P&Z STAFF REPORT

Board of Appeals Meeting, December 7, 2022

Case: **V22-0035 – 2480 Spalding Drive**
Staff Contact: LaQuita Williams (lwilliams@sandyspringsga.gov)
Report Date: November 14, 2022

Request for a variance from Division 9.2. State Waters Buffer to grade into the Undisturbed Natural Vegetative Buffer and 25' Impervious Surface Setback.

PROPOSED SITE PLAN/FINAL CONDITIONS (received November 3, 2022)

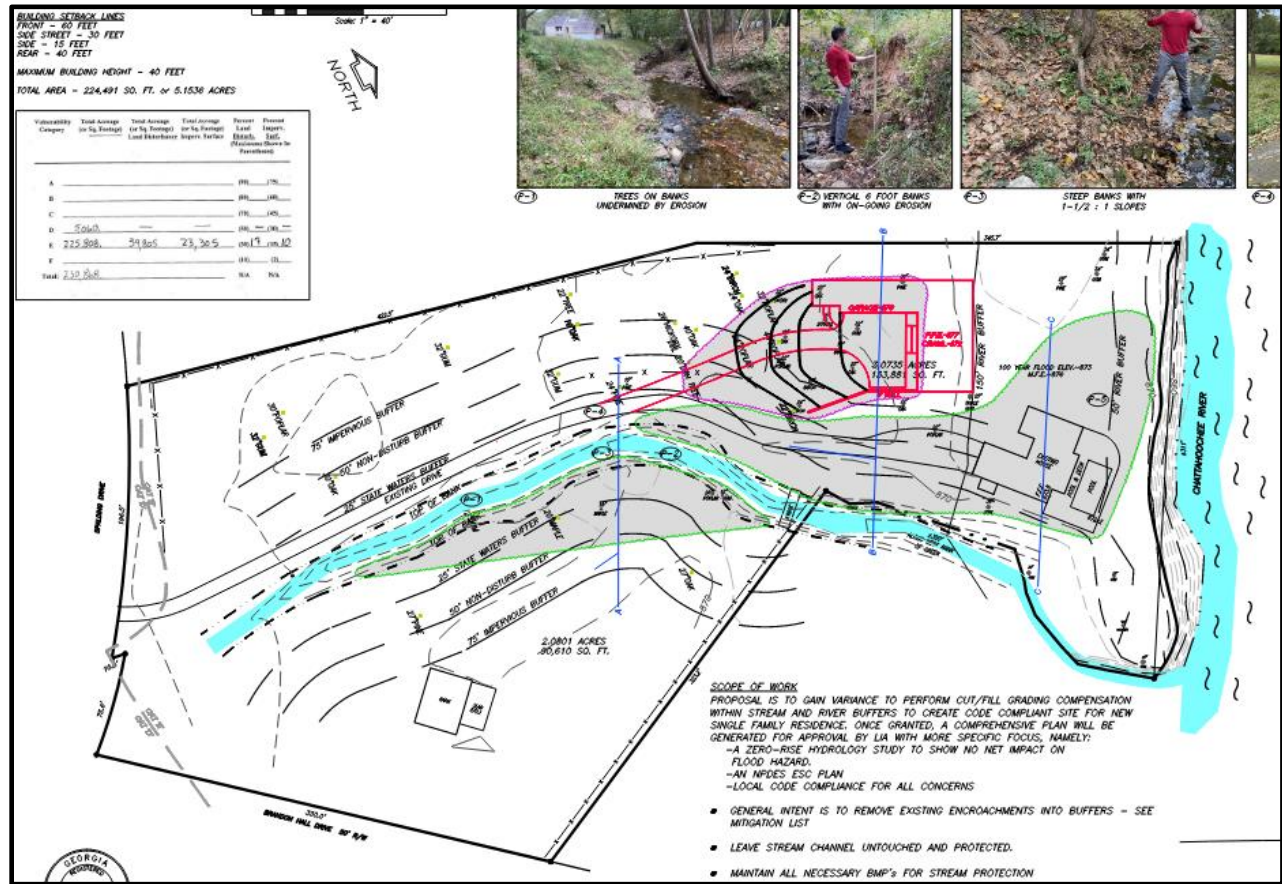
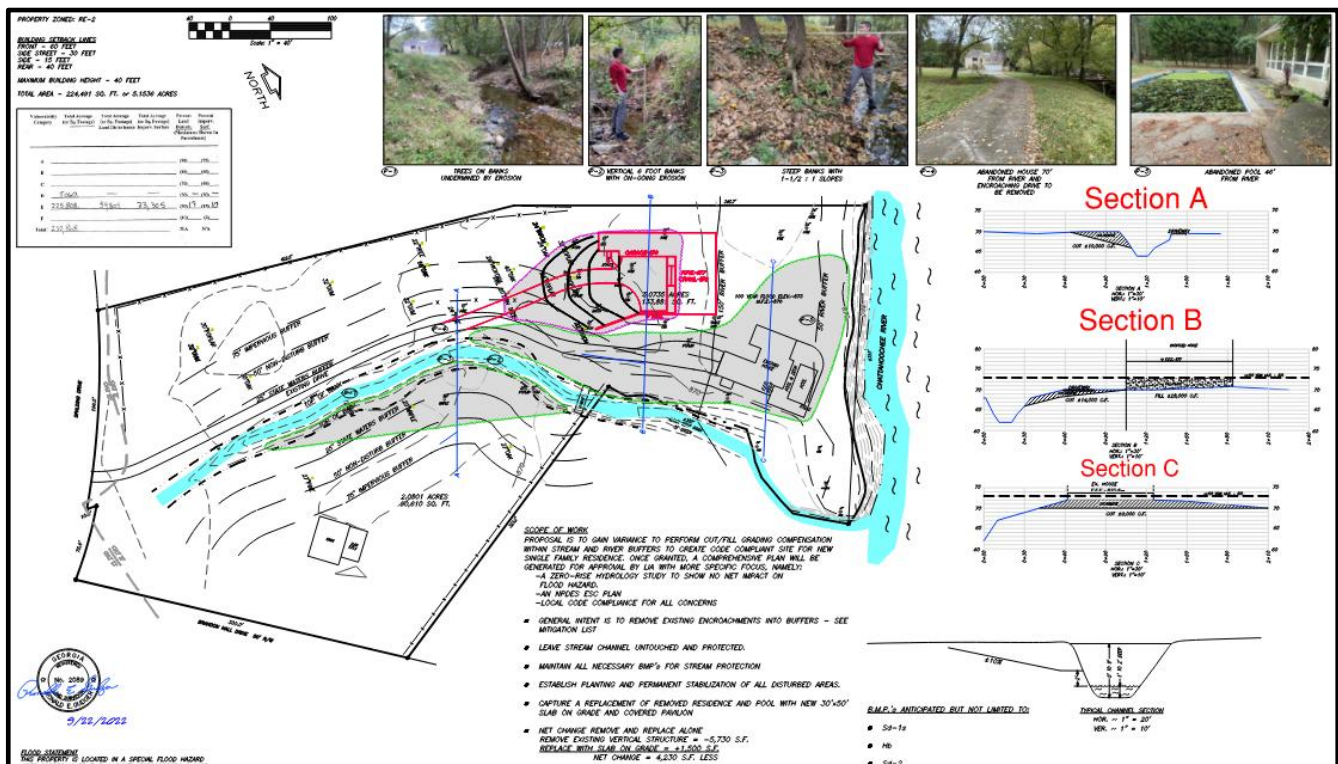
To the right of the site plan, are the cross sections of the cut/fill lines. The applicant is proposing to cut and fill to raise an area of the property above the floodplain to build a new home out of the river's buffer.

Section A shows the driveway which the applicant is proposing to cut away approximately 10,000 cubic feet to provide for additional flood capacity.

Section B shows a section close to the existing driveway which the applicant is proposing to cut away approximately 14,000 cubic feet and fill with approximately 28,000 cubic feet for the proposed home.

Finally in Section C, the applicant is proposing to cut approximately 9,000 cubic feet in an area where the existing home is to provide for additional flood capacity.

The applicant is seeking to cut and fill in the undisturbed natural vegetative buffer, state waters buffer and impervious surface setback. The City of Sandy Springs does not have the authority to allow for land disturbance in the 25' State Waters Buffer.

Findings: By grading into the buffers, erosion will occur, and sediment will travel and impact the Chattahoochee River.

THIS SITE REQUIRES THE FOLLOWING APPROVALS EXTERNAL TO SANDY SPRINGS: 1. FEMA Conditional Letter of Map Revision (CLOMR). 2. Georgia EPD Buffer Variance. City Engineer recommends the above approvals be obtained prior to consideration for Buffer Variance by City of Sandy Springs.

The application does not show the site meeting the minimum canopy requirement. The site would be required to adhere to the minimum canopy requirement of 35%. Impacts to Protected Trees and Landmark Trees would occur with the proposed site plan; therefore, mitigation plantings and recompense would be required. Please be aware that Division 9.3 of the Sandy Springs Development Code details the tree conservation requirements associated with developing the site. If the variance is approved, review Section 1E, state water buffers restoration standards, in the Sandy Springs Technical Manual.

Proposed Development

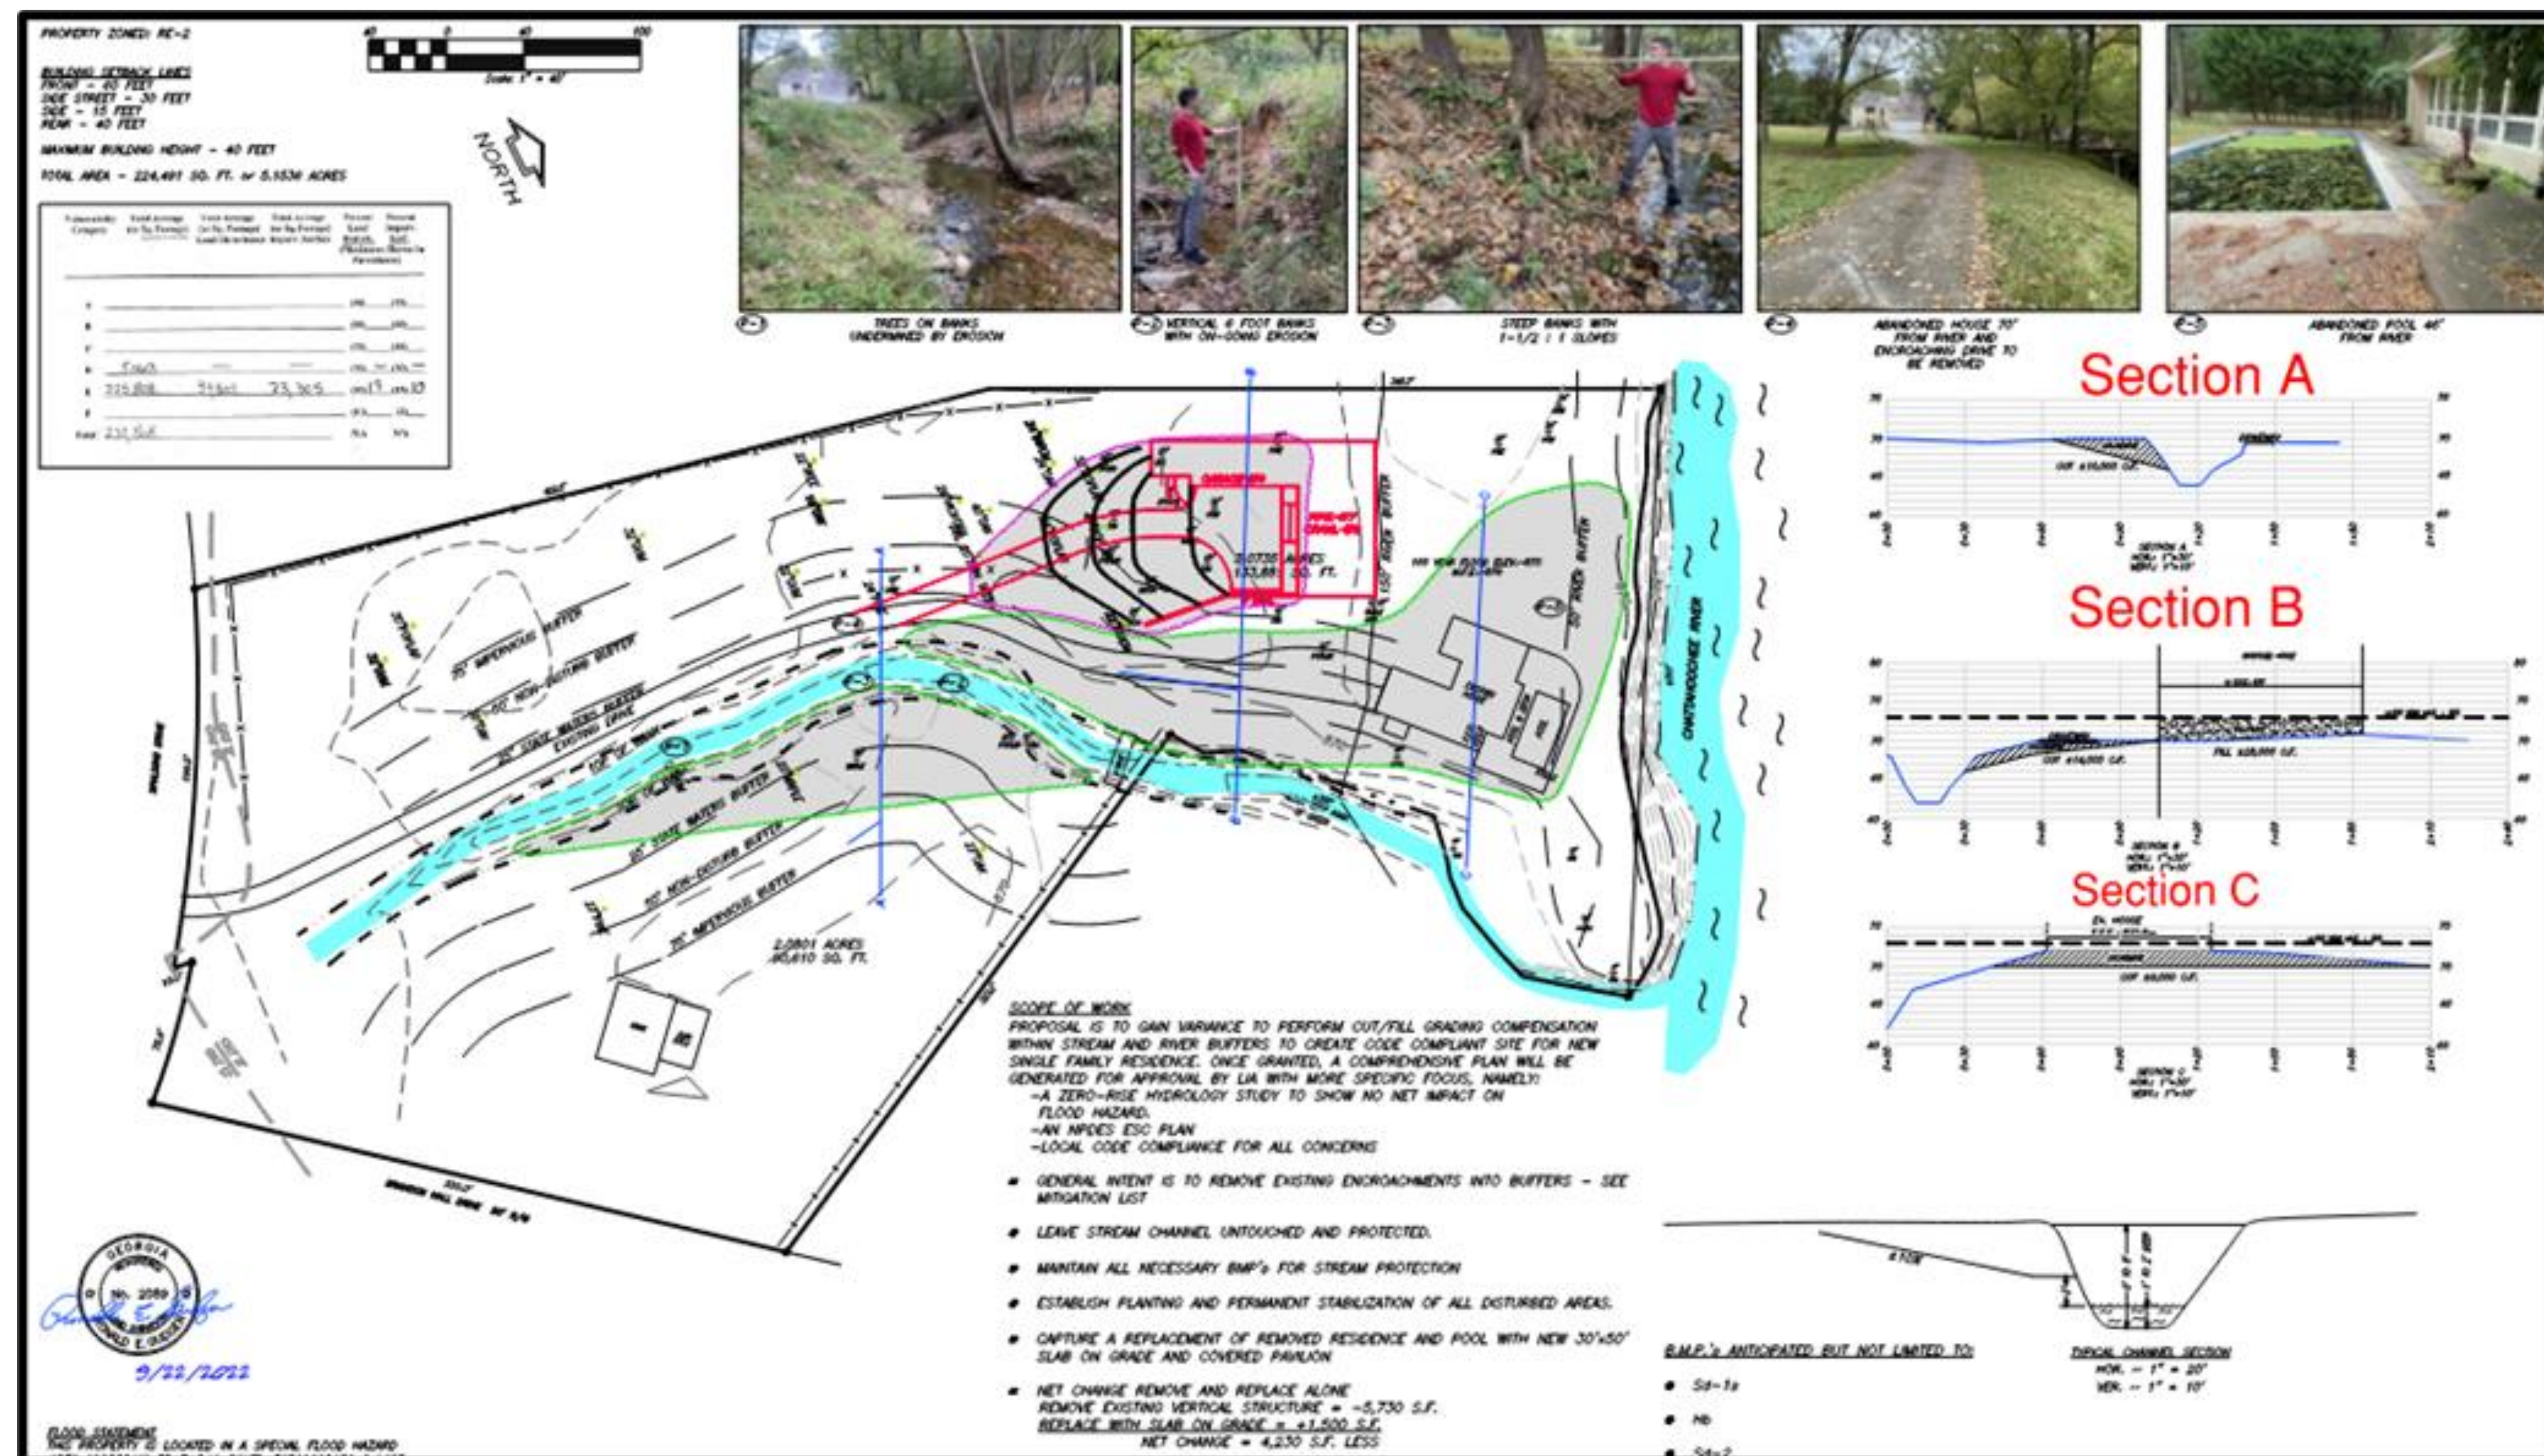
- The applicant is seeking a variance to cut/ fill (grading of earth) within the stream buffers. The applicant's proposed grading, totaling over an acre of land disturbance, is necessary to build a new home at least three feet above the floodplain. The applicant is also proposing to demolish the existing home.

- The applicant is attempting to provide for additional floodplain capacity in order to build a new home out of the 50' river buffer.
- The applicant is encroaching in the 50-foot undisturbed vegetative buffer and the 150-foot impervious surface setback on the Chattahoochee and its impoundments.

Section A includes cutting approximately 10,000 cubic feet near the driveway.

Section B includes cutting approximately 14,000 cubic feet and filling approximately 28,000 cubic feet.

Section C, the proposal includes cutting approximately 9,000 cubic feet under the existing house
